ADDENDUM NUMBER: TWO

PROJECT: New Field House – Northern Nash High School
4230 Green Hills Road
Rocky Mount, North Carolina 27804

PROJECT NO: 21038

DATE: May 17, 2023

GENERAL NOTE: Prior to construction start. Contractor shall verify & be responsible for all Dimensions.		
Revisions		
	Description	Date
	ADDEN #1	05/16/23
Date	Project No.	
4-24-23	21038	
Drawn By	Sheet No.	
GS	FA1.1	
Checked By		
DWP		
Sheet Title		
FIRE ALARM PLAN

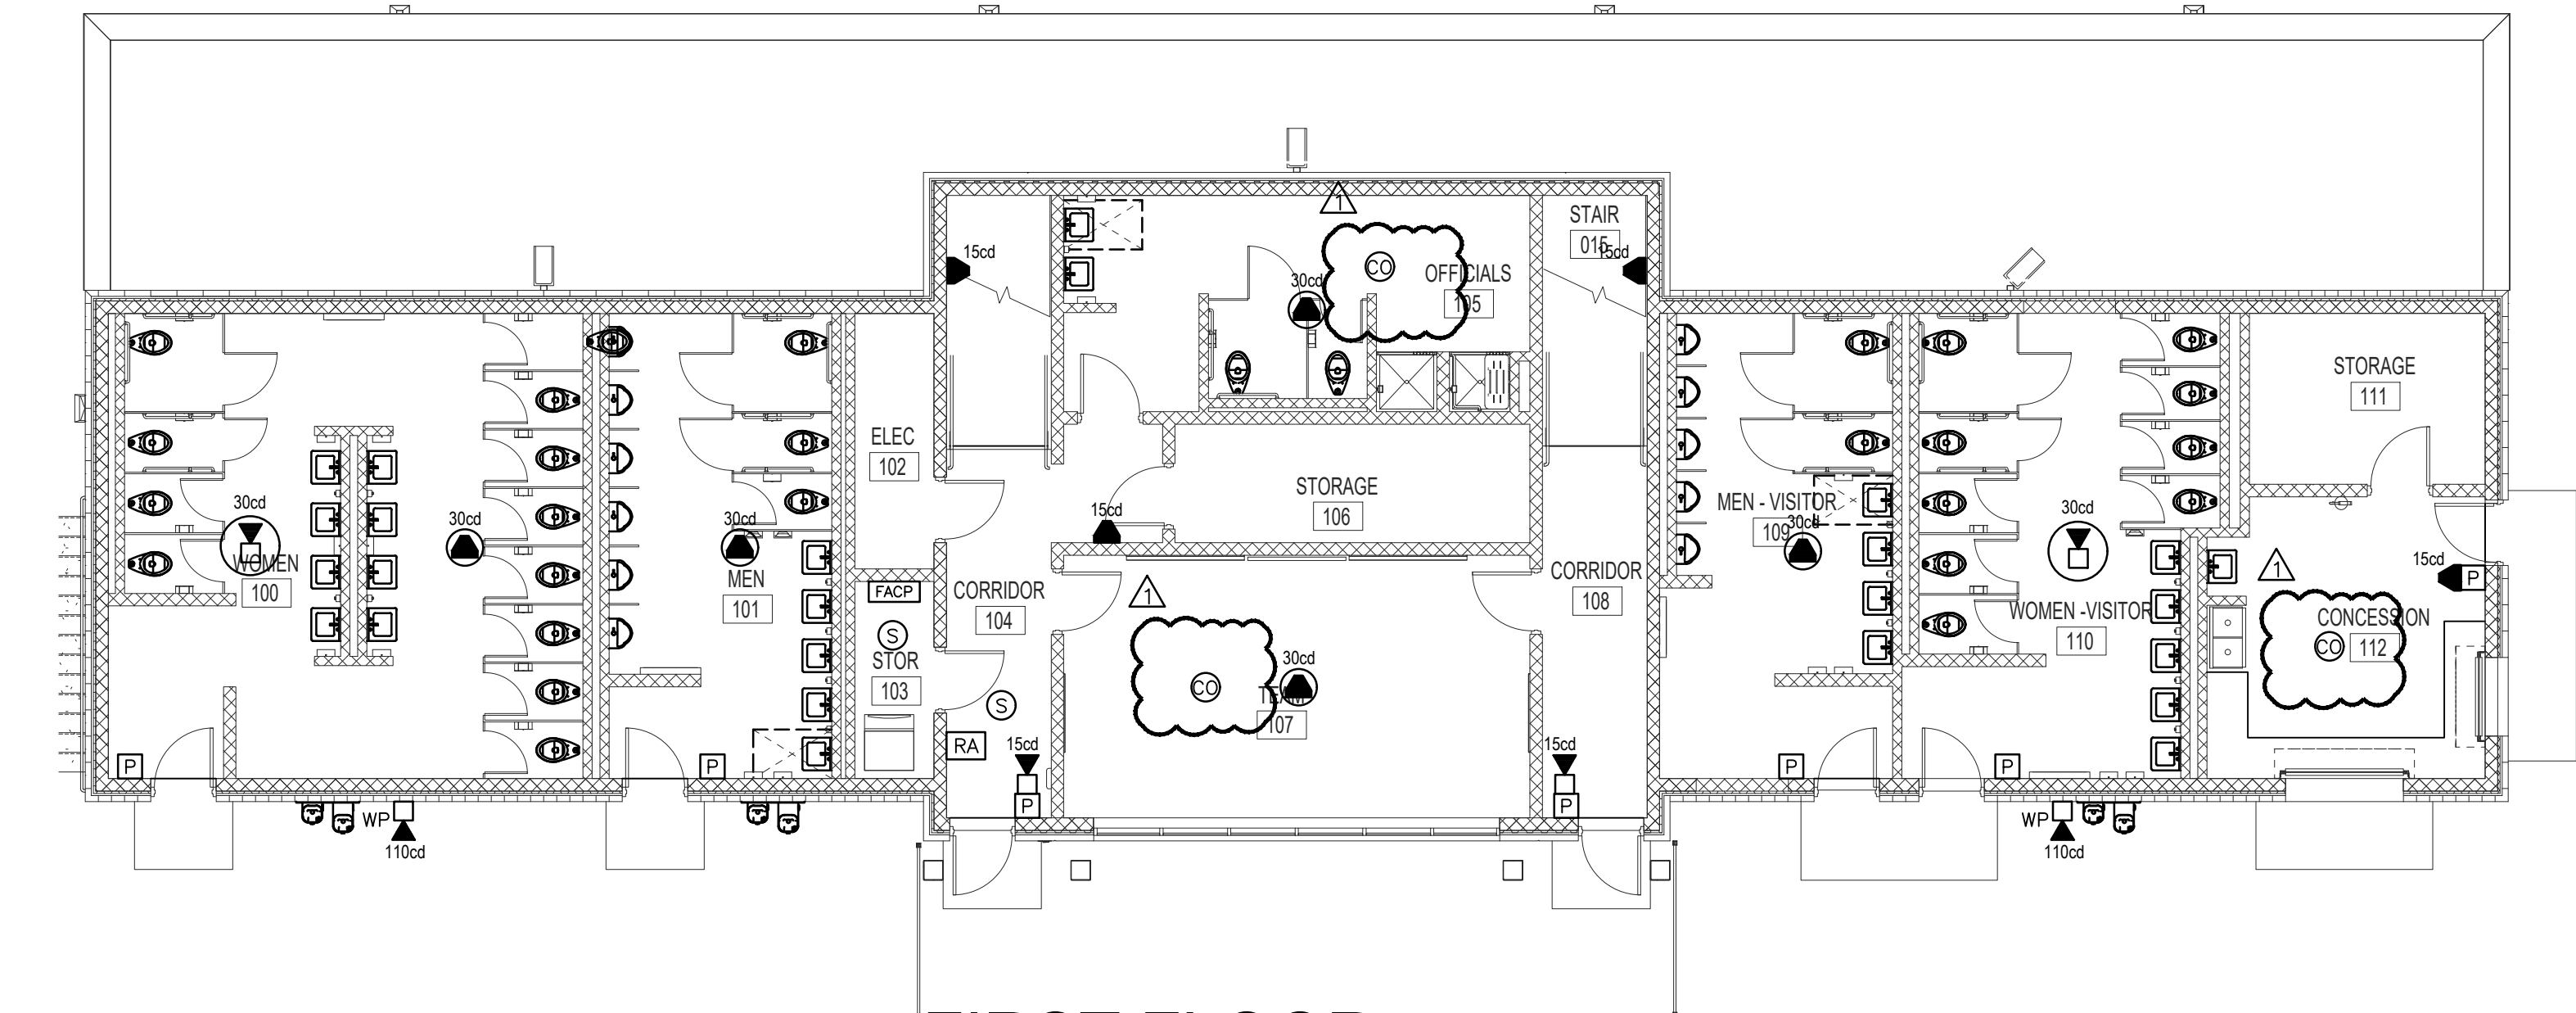
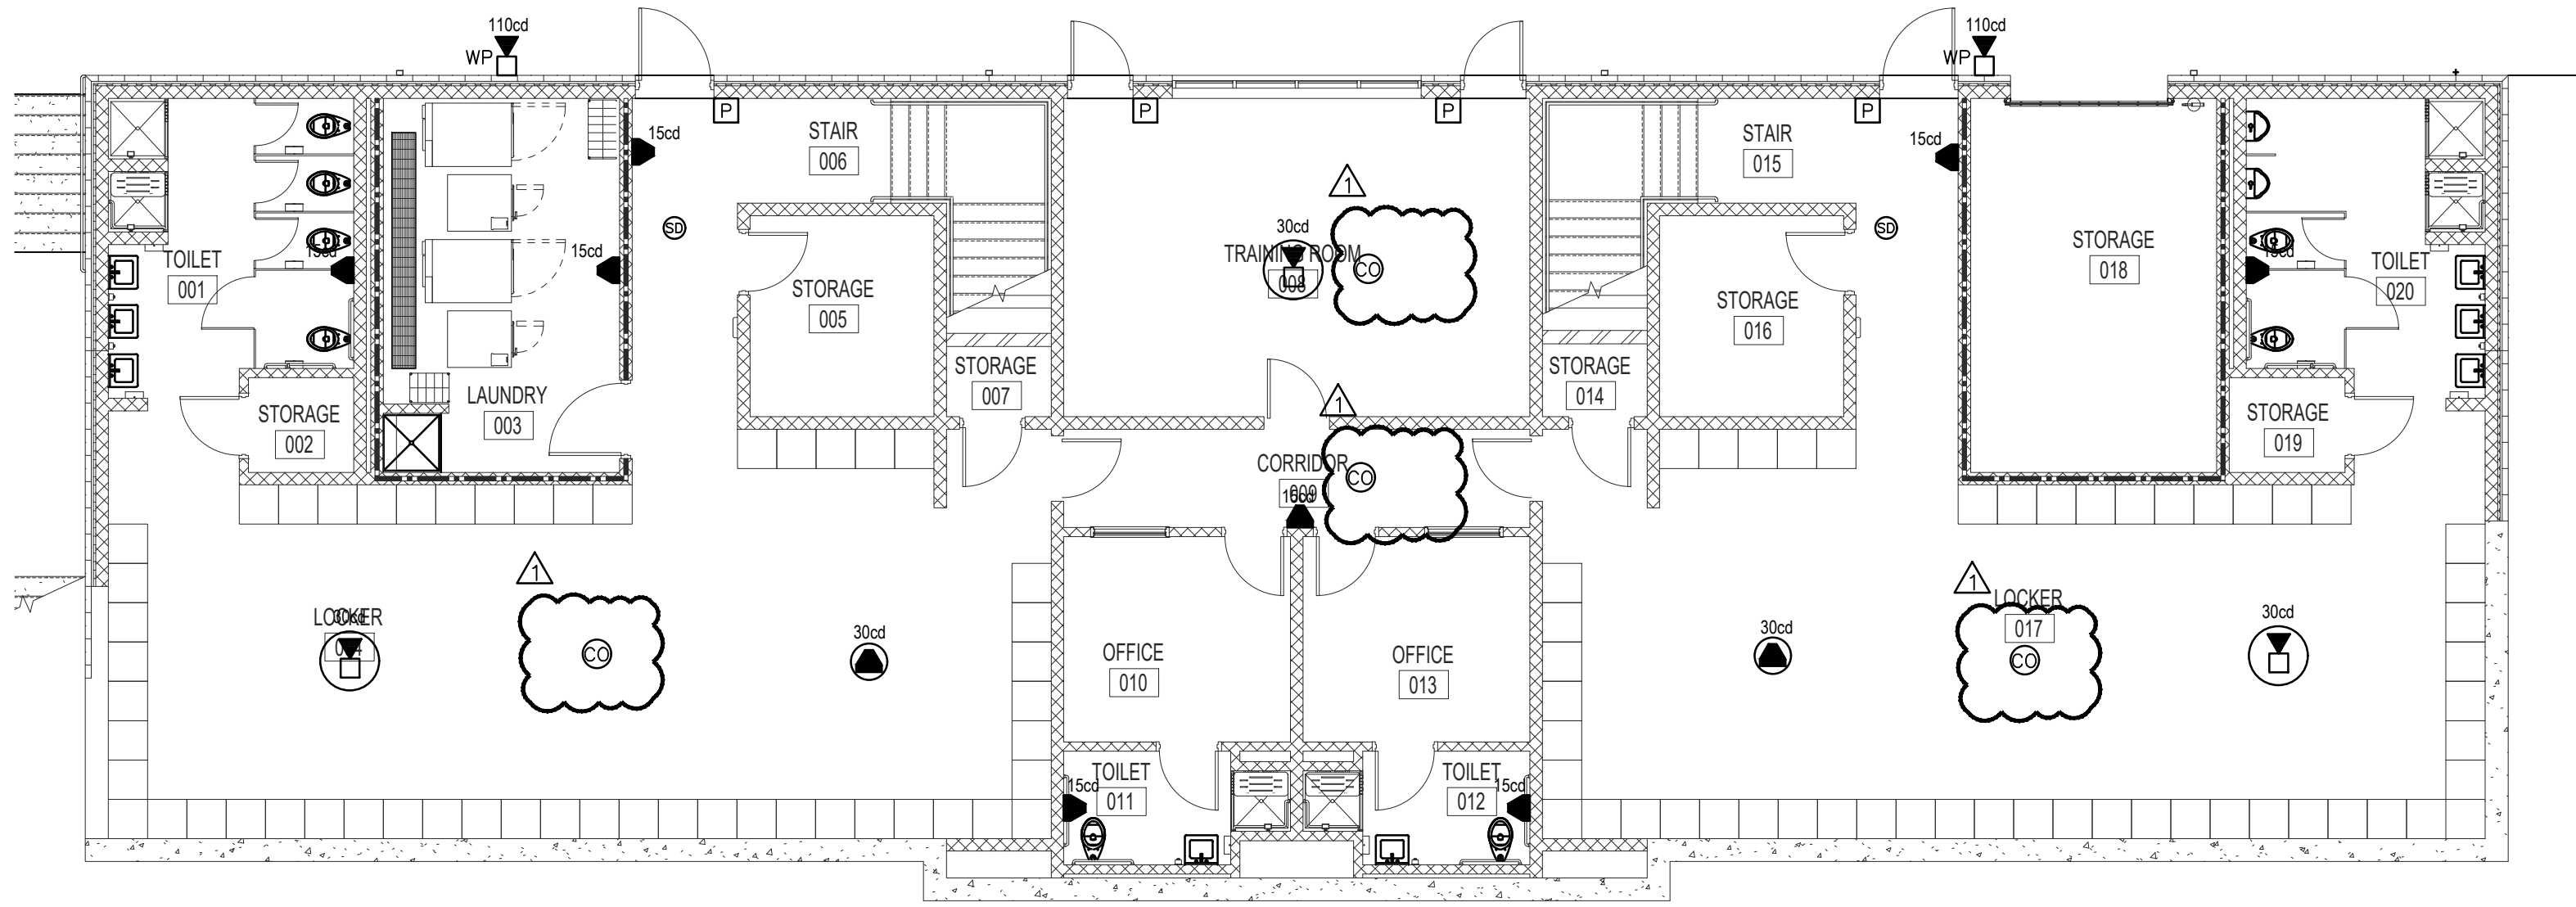
- Item 5 Change** **Sheet FA1.1**
Remove the existing sheet in its entirety and replace it with the attached sheet – Added (7) carbon monoxide detectors.
